Regarding your answer to question 1. Please include in your answer all capabilities of the device. Please include vocoder details as well as radio configurations/service options and similar.

Regarding your answer to question 6. Please provide details of the setup for this test. Was the LISTEN system used? Given the frequency response data listed please justify that the probe meets the .5 dB specification from C63.19 Annex C5

Figure A
P.50 Artificial Voice Signal

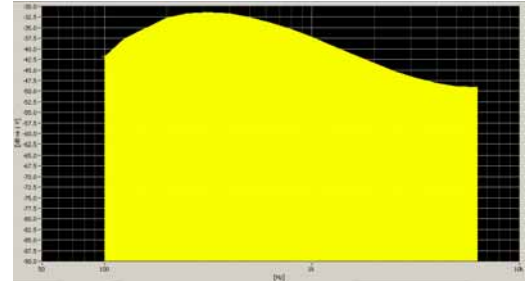
Regarding your answer to question 7 please include details of the P50 source and measurement system for this procedure.

Please see below for specification for the P.50 source used in the LISTEN system.

Manufacturer: ITU-T
Active Frequency Range: 100 Hz – 8 kHz
Stimulus Type: Male and Female, no spaces
Single Sample Duration: 20.96 seconds

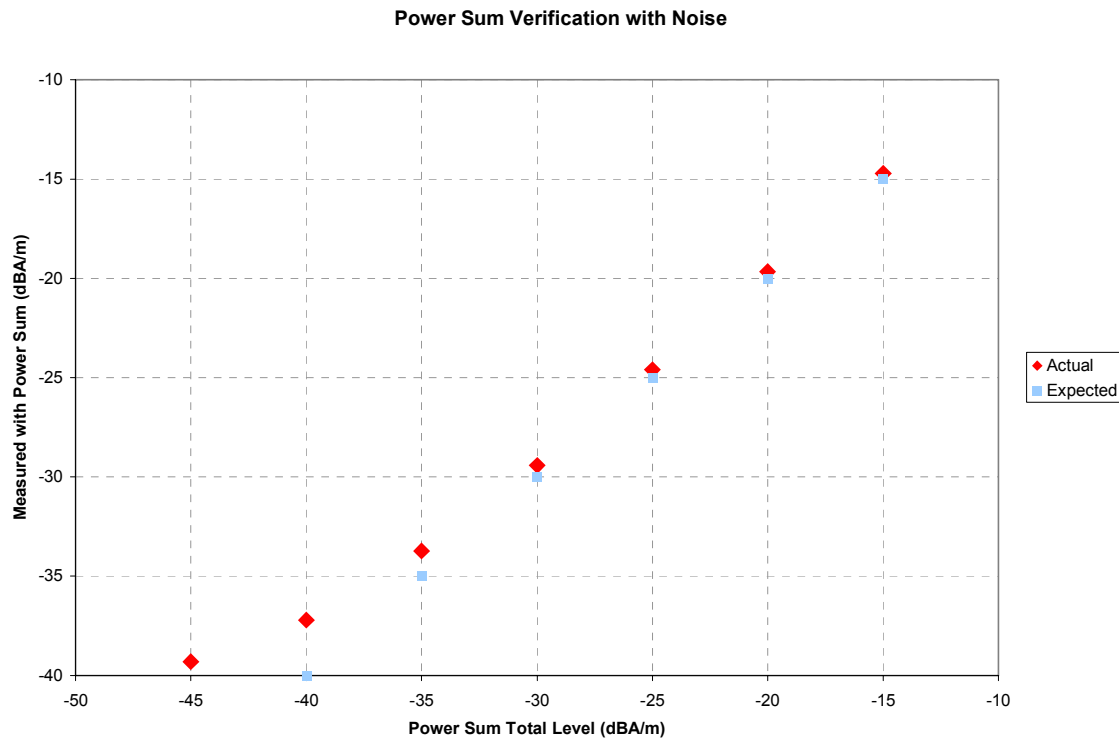
Regarding your answer to question 9 please demonstrate that the frequency response for the ABM2 system is as recommended in C63. Please demonstrate the overall resulting sum works as expected. One option for the later might be to compare expected result progression as each curve is added for a white Gaussian noise input.

Please see below Gaussian white noise level vs. measured (with sum) actual measurements:

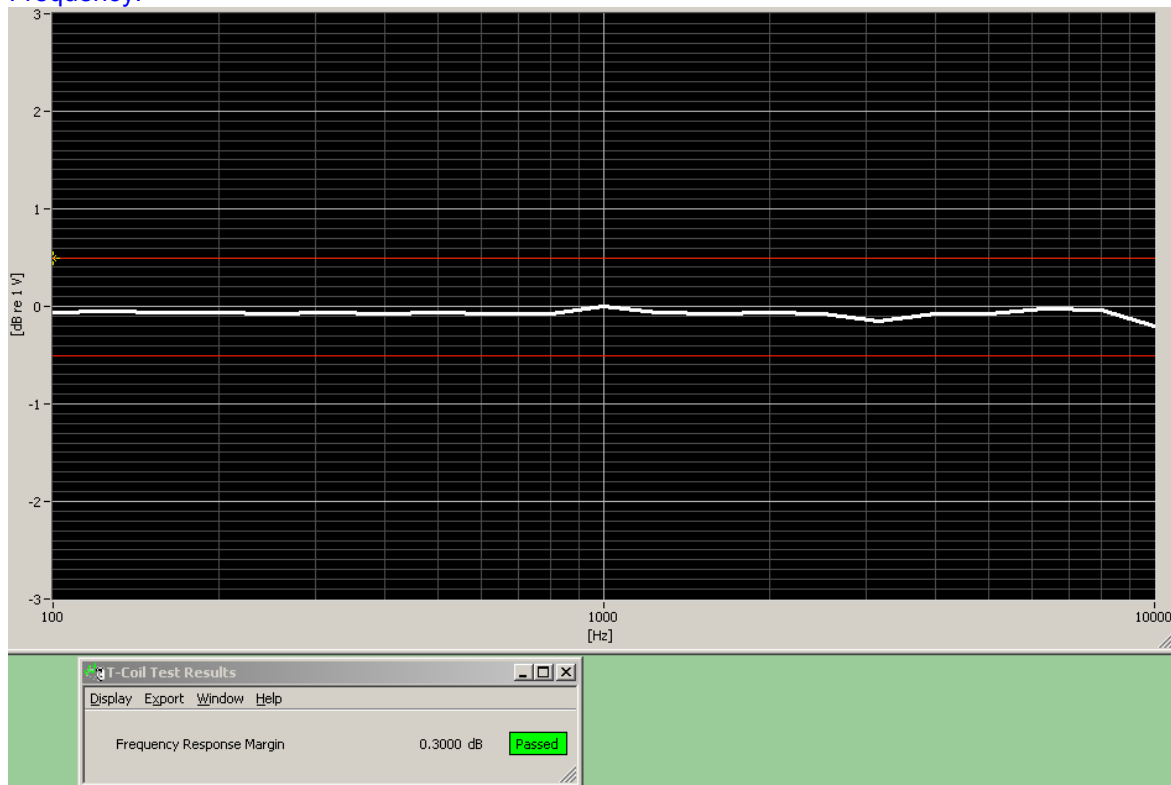
Regarding your answer to question 14 We understand that once the TEM system has located the probe at the maximum location than the probe output is manually switched over to the Listen input. Please confirm. Please clarify that the LISTEN connection was used for all key calibration/verification procedures.

We confirm the LISTEN connect was used for all key verification procedures.

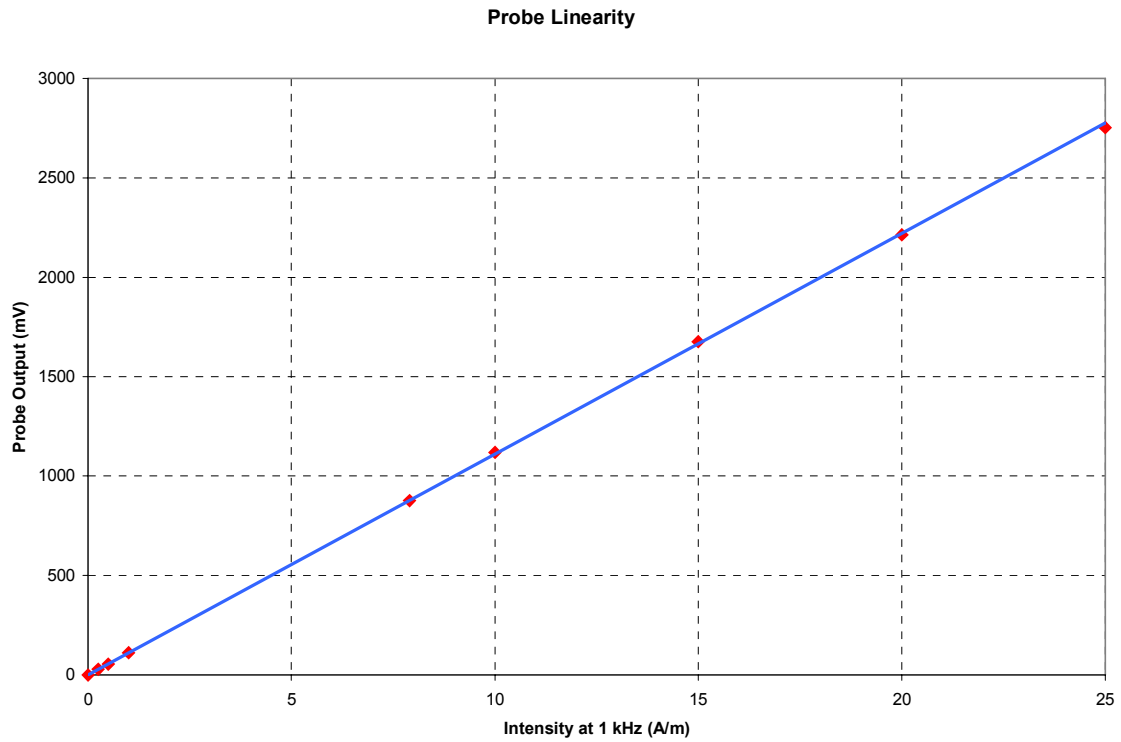
Regarding your answer to question 16 please detail the conditions of the test for probe calibration certificates. It appears to be probe only. Please discuss how the result with probe/system combination will be. The FCC has seen composite effects from both amplifier impedance and cable capacitance. It may be preferable to perform these calibration steps as a system including cable.

The calibration steps were performed using the LISTEN probe/system with all equipment/cables used during testing, as shown below.

Linearity:

Measurement Processing Chain for Linearity:
